REQUEST FOR INFORMATION DATE: November 04, 2016 **NO.:** RFI-344

Project Name: 15051-Webster University Interdisciplinary Science Building Project No.: 15051

Subject: S0104 & E2B (L3), and E6A (L4) at B.3 - 1

Project: WEBSTER UNIVERSITY INTERDISCIPLINARY SCIENCE BUILDING
Customer: PARIC CORPORATION
Owner: WEBSTER UNIVERSITY
Location: WEBSTER GUOVES, MO 63119
Dwn: ZZ Date: 05/30/2016 Ckd: LJ Date: 08/04/2016
Job No. A16013 BAT: _____ DWG#: 269

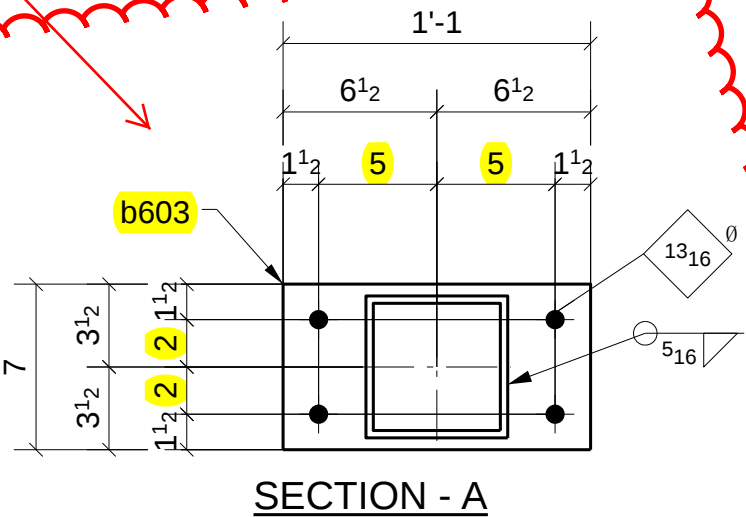
The field reports that, for some un-known reason, the 4" x 10" bolt pattern in the base-plate of column 603A did not match the 4" x 10" bolt pattern in the left end, top-flange of beam 269A. The attached details and gather sheets all show that the bolt patterns should have matched up. To continue with erection, they field-welded the column 603A base plate (b603) directly to the beam 269A flange with a 5/16" fillet weld all-around.

WELDED SOLUTION IS ACCEPTABLE

LEVEL 03 FLOOR FRAMING PLAN SEQ2
T.O.S. EL. +114'-9 1/2 (UNO)
REF: S0104

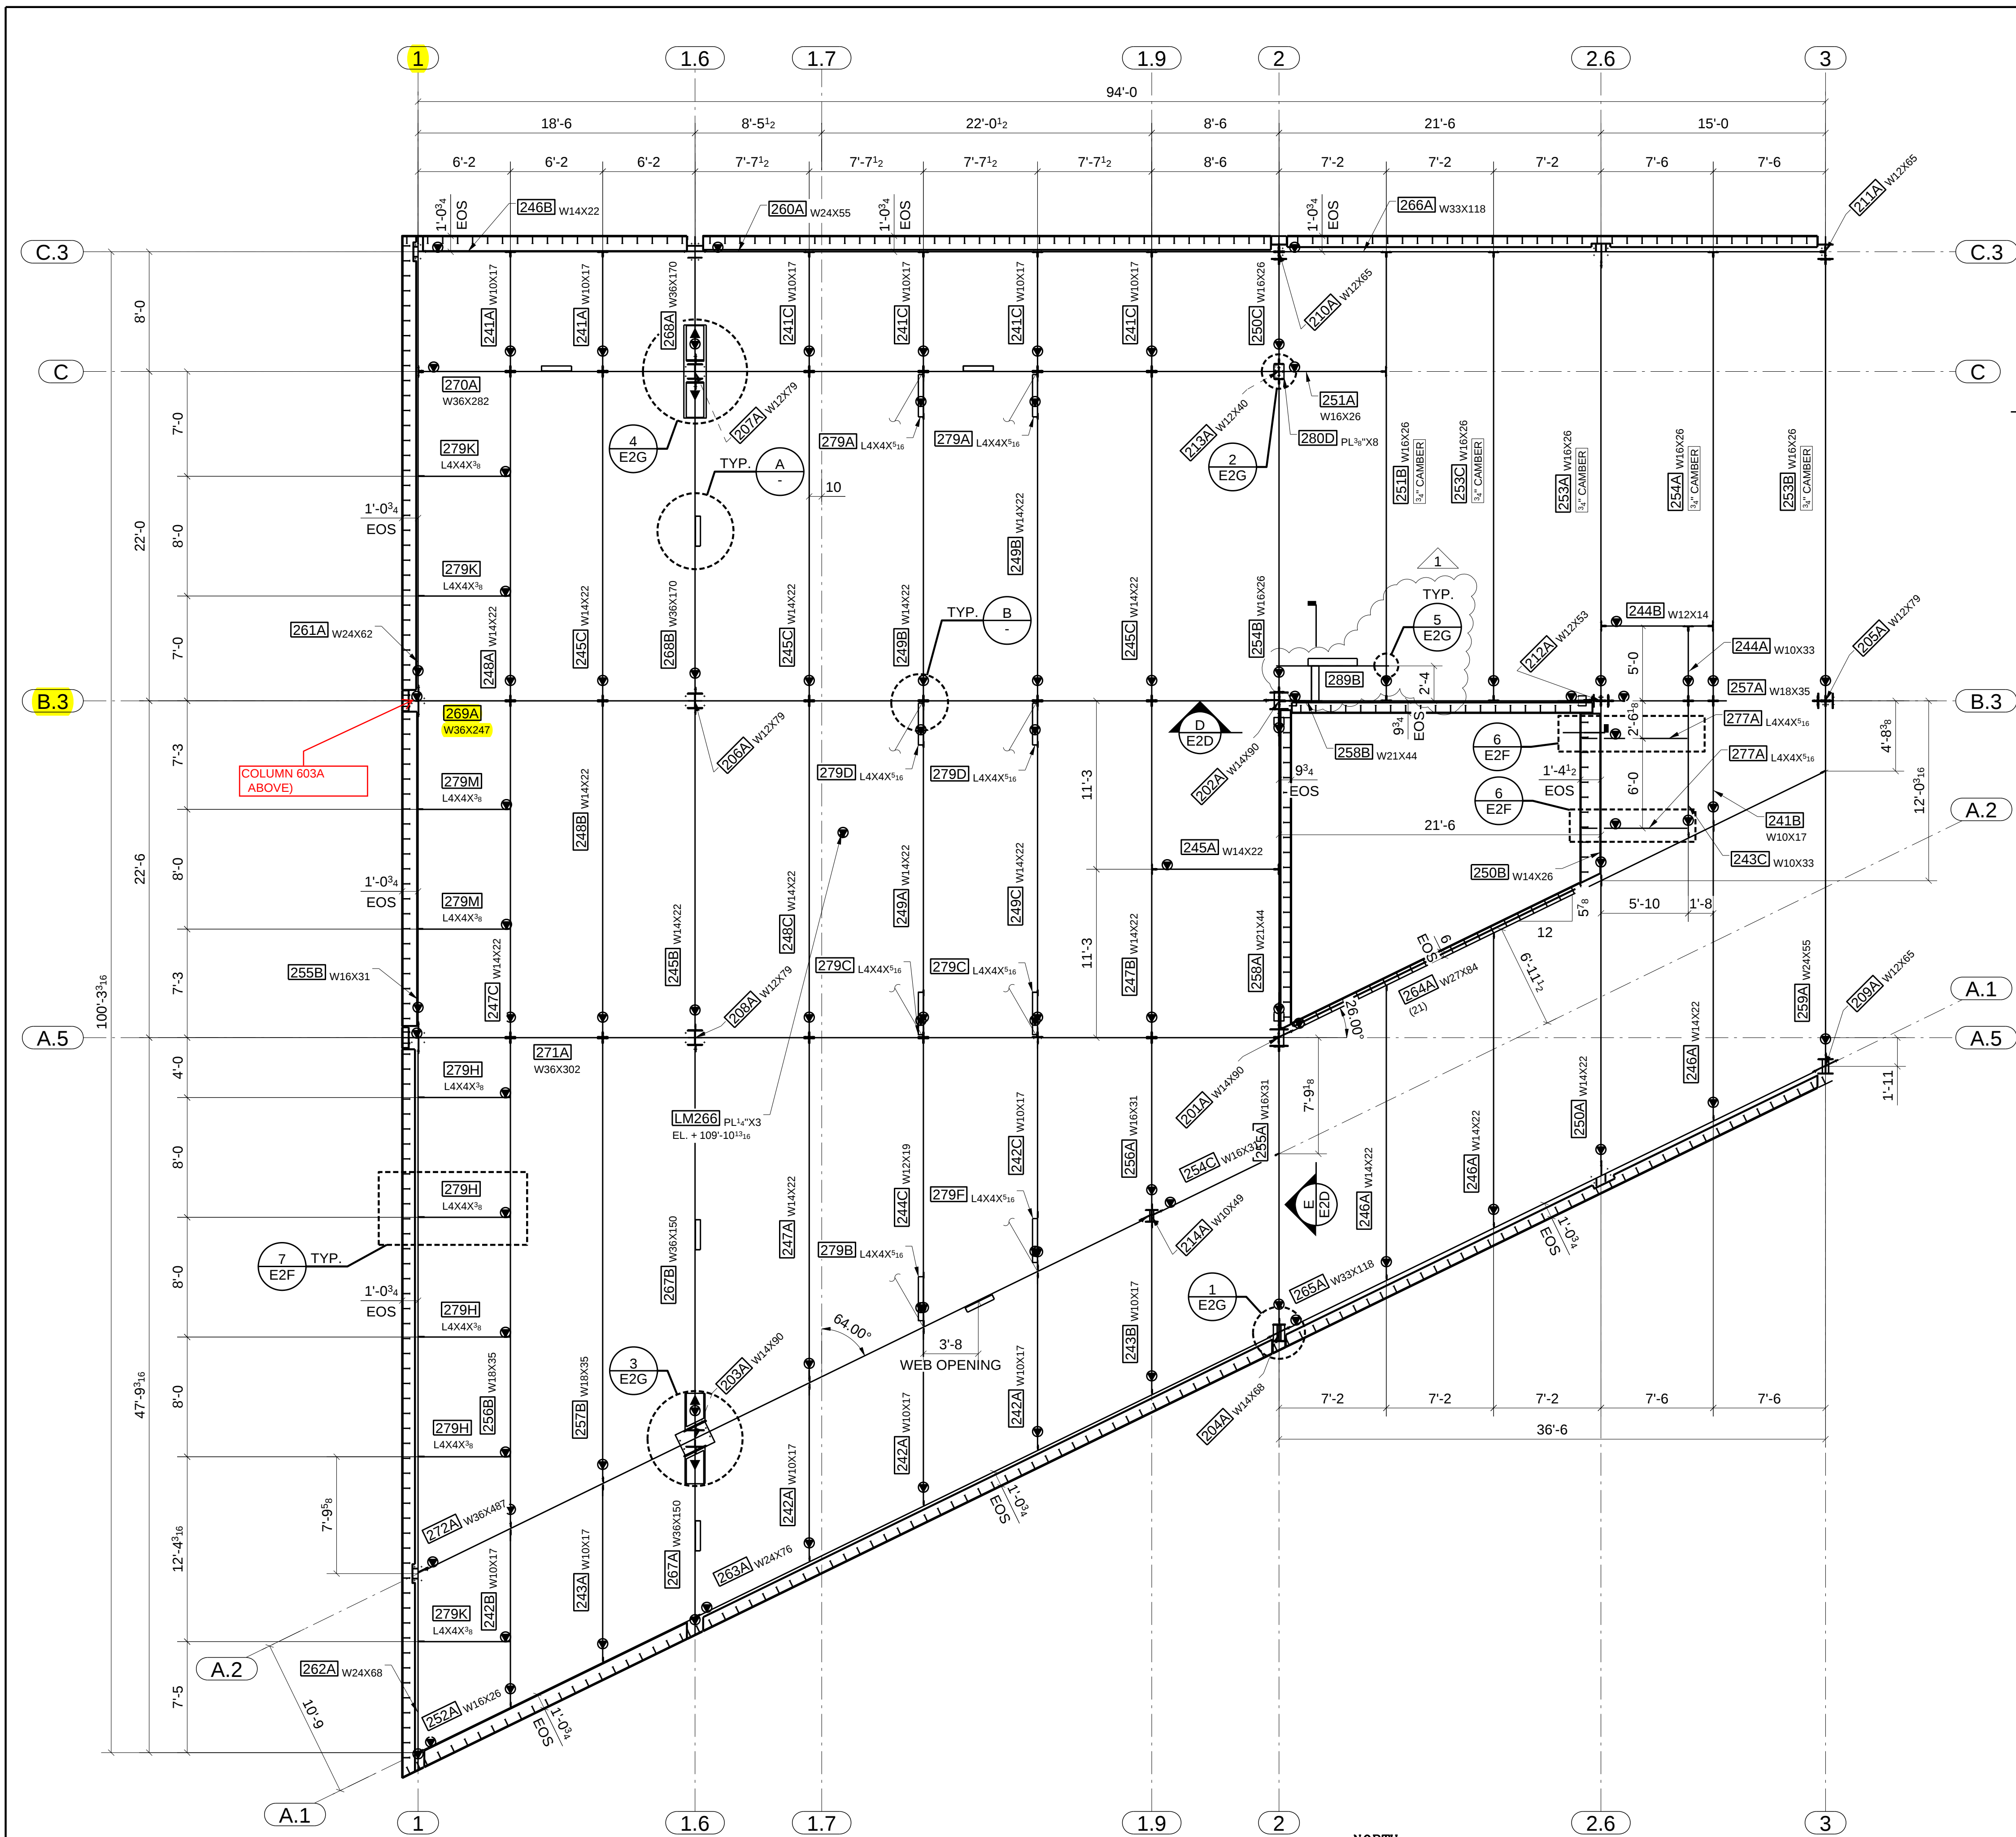
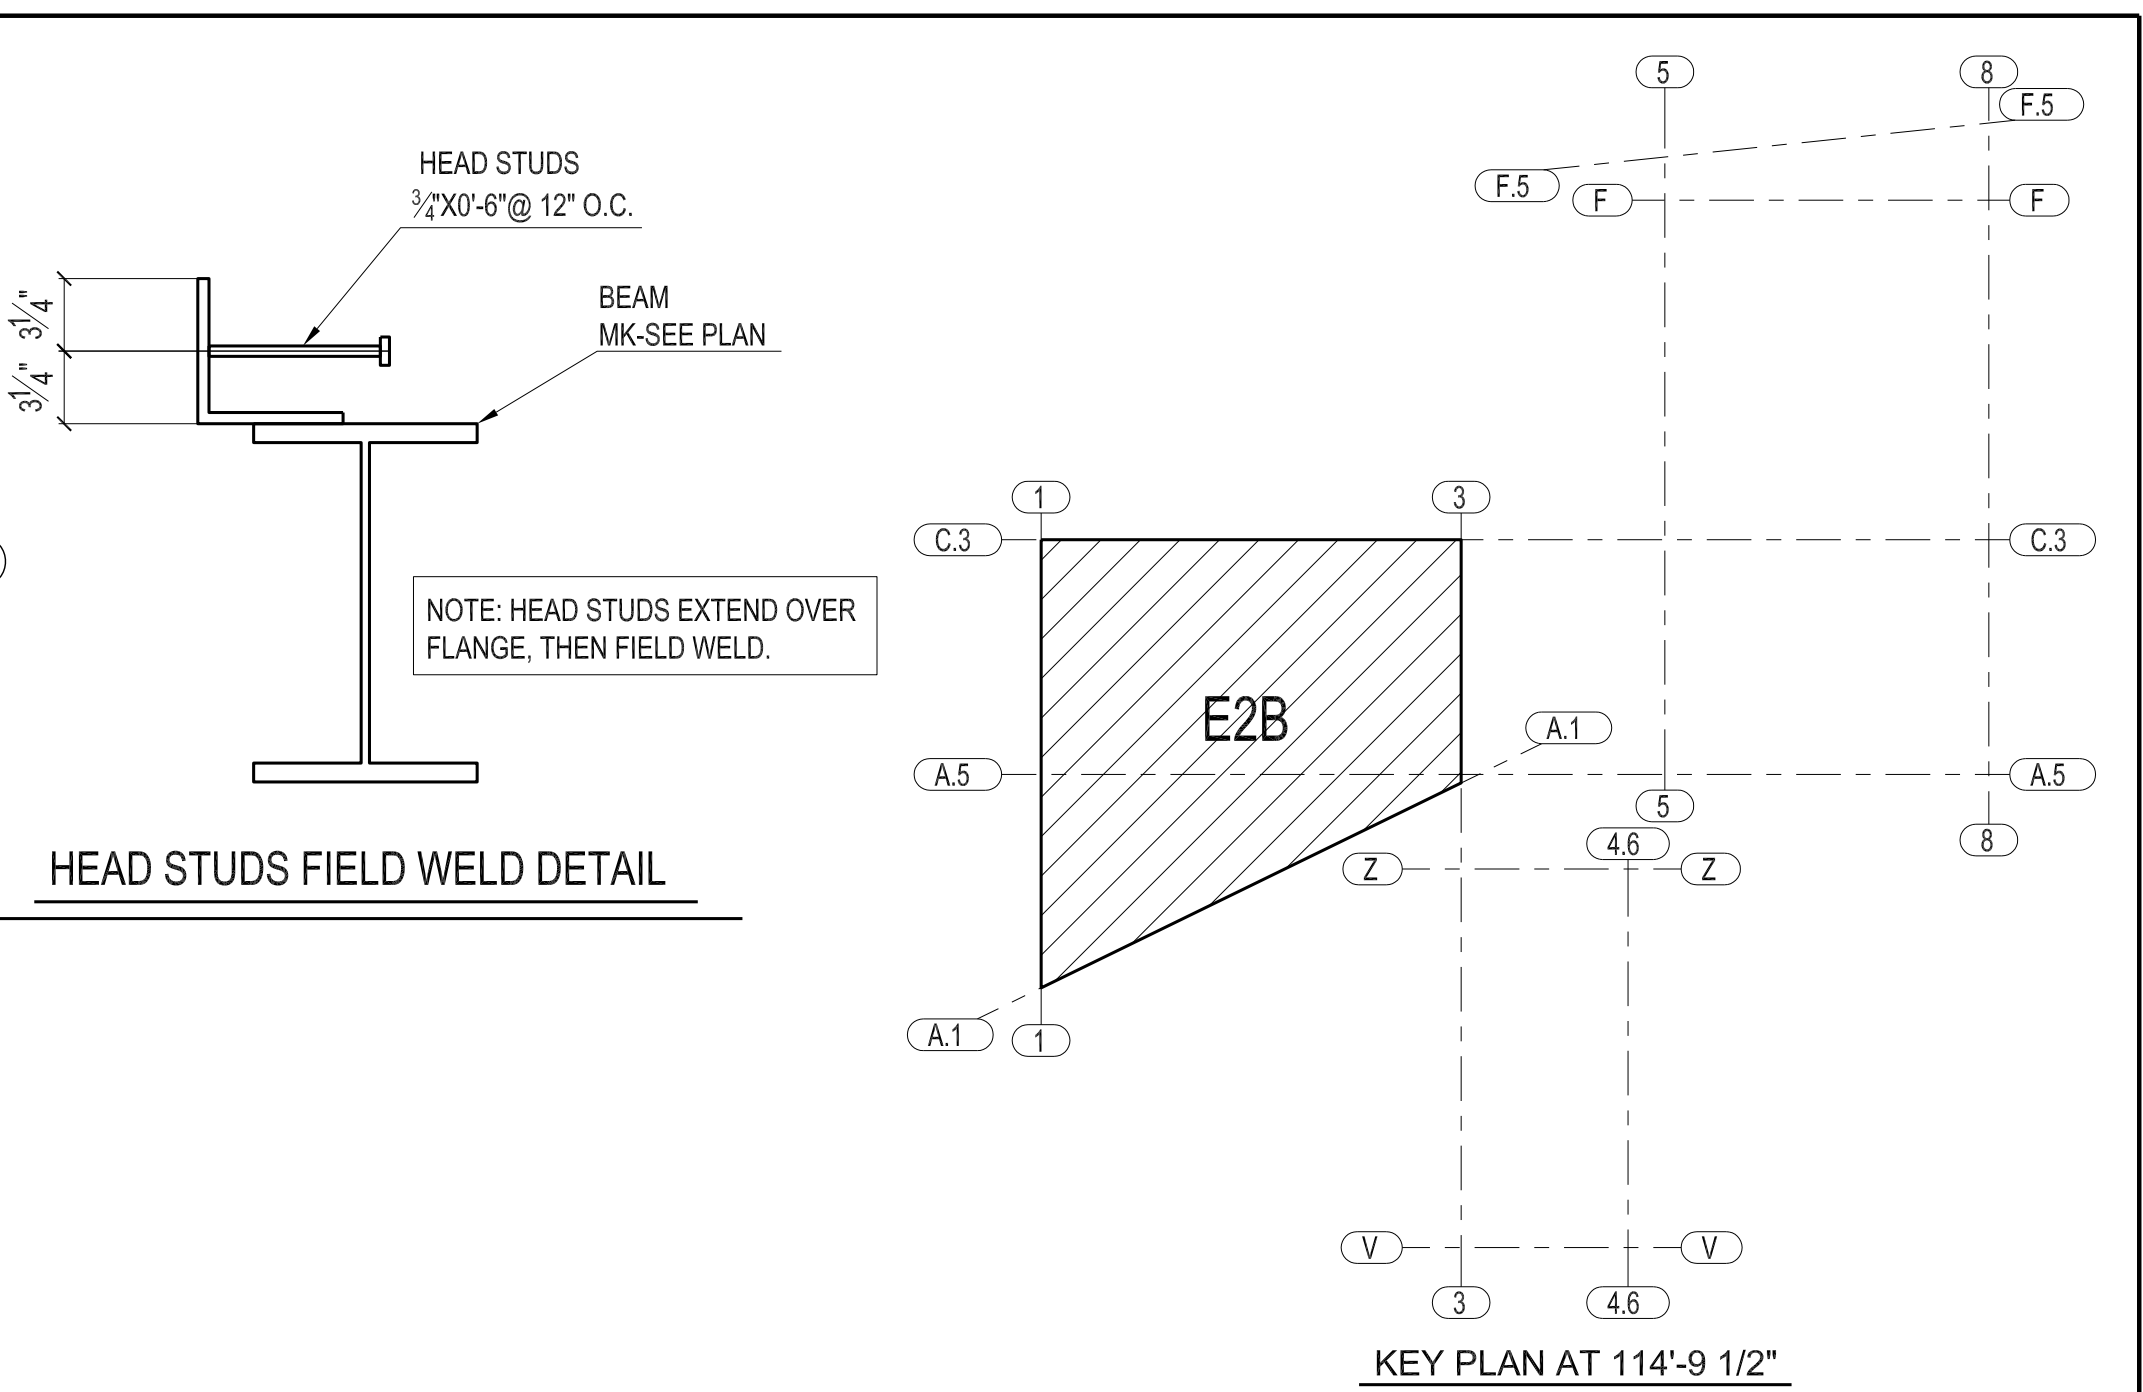
- Per the attached RFI 108 response, this column (at B.3-1) only required a 4-bolt connection to the beam under it.
